Project	<b>IEEE 802.16 Broadband Wireless Access Working Group</b> < <a href="http://ieee802.org/16">http://ieee802.org/16</a> >	
Title	<b>Clarification on Cooperative Relaying</b>	
Date Submitted	<b>2007-09-18</b>	
Source(s)	<p>Aik Chindapol, Jimmy Chui, <a href="mailto:aik.chindapol@siemens.com">aik.chindapol@siemens.com</a>  Adrian Boariu, Shashikant Maheshwari,  Haihong Zheng, Yousuf Saifullah, Peter Wang  Nokia Siemens Networks</p> <p>Kyu Ha Lee, Young-Jae Kim, Changkyoon Kim  Samsung Thales  San 14, Nongseo-Dong, Giheung-Gu,  Yongin, Gyeonggi-Do, Korea 449-712  Voice: +82-31-280-9917  Fax: +82-31-280-1562  <a href="mailto:kyuha.lee@samsung.com">kyuha.lee@samsung.com</a></p> <p>Byung-Jae Kwak, Sungcheol Chang,  D. H. Ahn, Young-il Kim  ETRI  161, Gajeong-Dong, Yuseong-Gu,  Daejeon, Korea 305-350  Voice: +82-42-860-6618  Fax: +82-42-861-1966  <a href="mailto:bjkwak@etri.re.kr">bjkwak@etri.re.kr</a></p>

# Clarification on Cooperative Relaying

This contribution is a response to comments regarding cooperative relaying and merges RS\_CDC-REQ into the RS\_CD zone configuration IE (Remedy 1), RS\_CD-REQ (Remedy 2) or RS\_Config-REQ (Remedy 3) to reduce overhead and to allow per-zon

**Figure 323a—A logical block example of local STC Encoding at RS. The STC Encoder is identical to the encoder in Figure 244[Figure 301 in Rev2] of Section 8.4.8.1.**

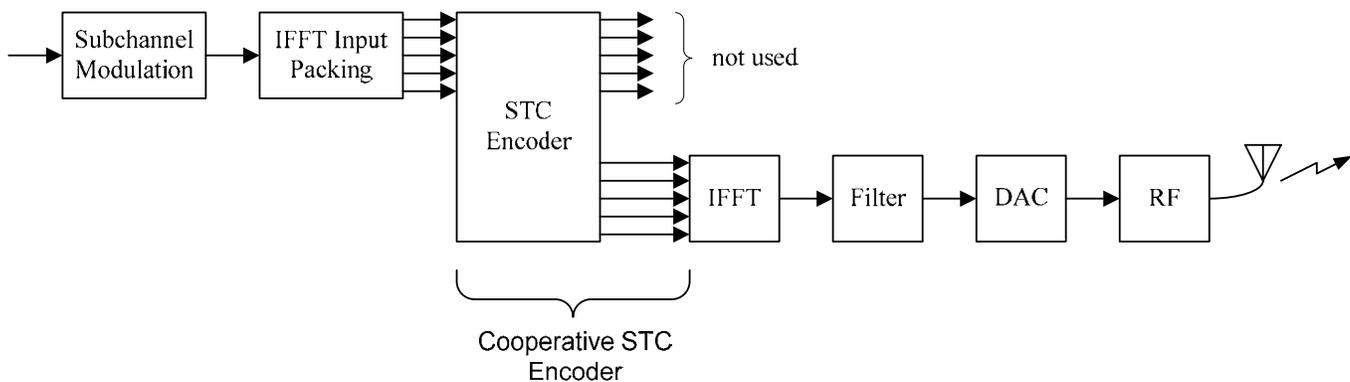
-Figure 323a is an example of local STC encoding at the RS. The STC Encoder is identical to the encoder in Figure 244[Figure 301 in Rev2] of 8.4.8.1.

**Figure 323a—A logical block example of local STC Encoding at RS. ~~The STC Encoder is identical to the encoder in Figure 244[Figure 301 in Rev2] of Section 8.4.8.1.~~**

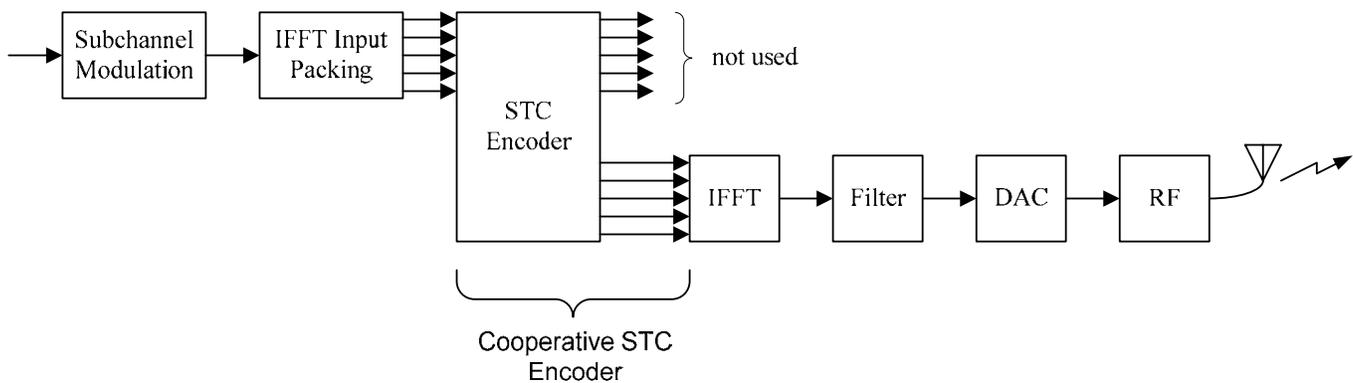
-Figure 323a is an example of local STC encoding at the RS. The STC Encoder is identical to the encoder in Figure 244[Figure 301 in Rev2] of 8.4.8.1.

**Figure 323a—A logical block example of local STC Encoding at RS. ~~The STC Encoder is identical to the encoder in Figure 244[Figure 301 in Rev2] of Section 8.4.8.1.~~**

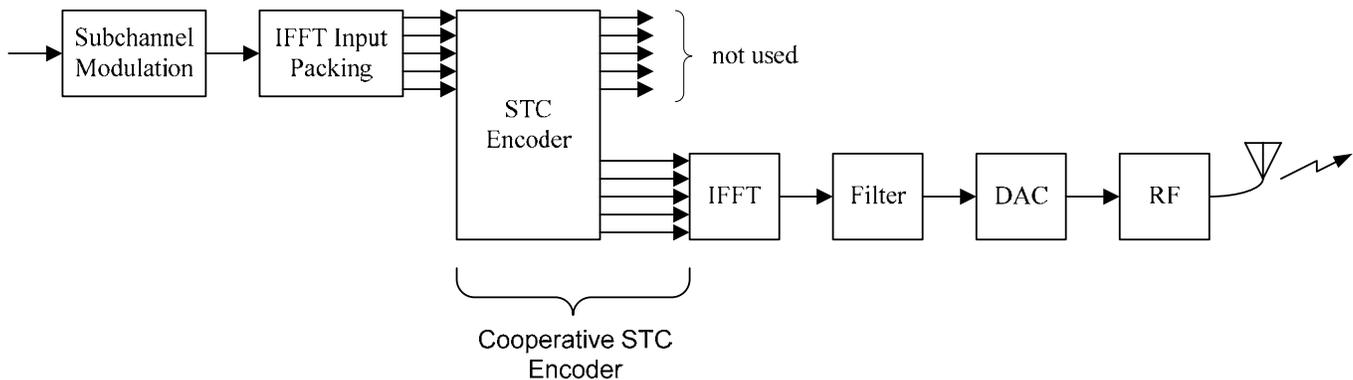
-Figure 323a is an example of local STC encoding at the RS. The STC Encoder is identical to the encoder in Figure 244[Figure 301 in Rev2] of 8.4.8.1.
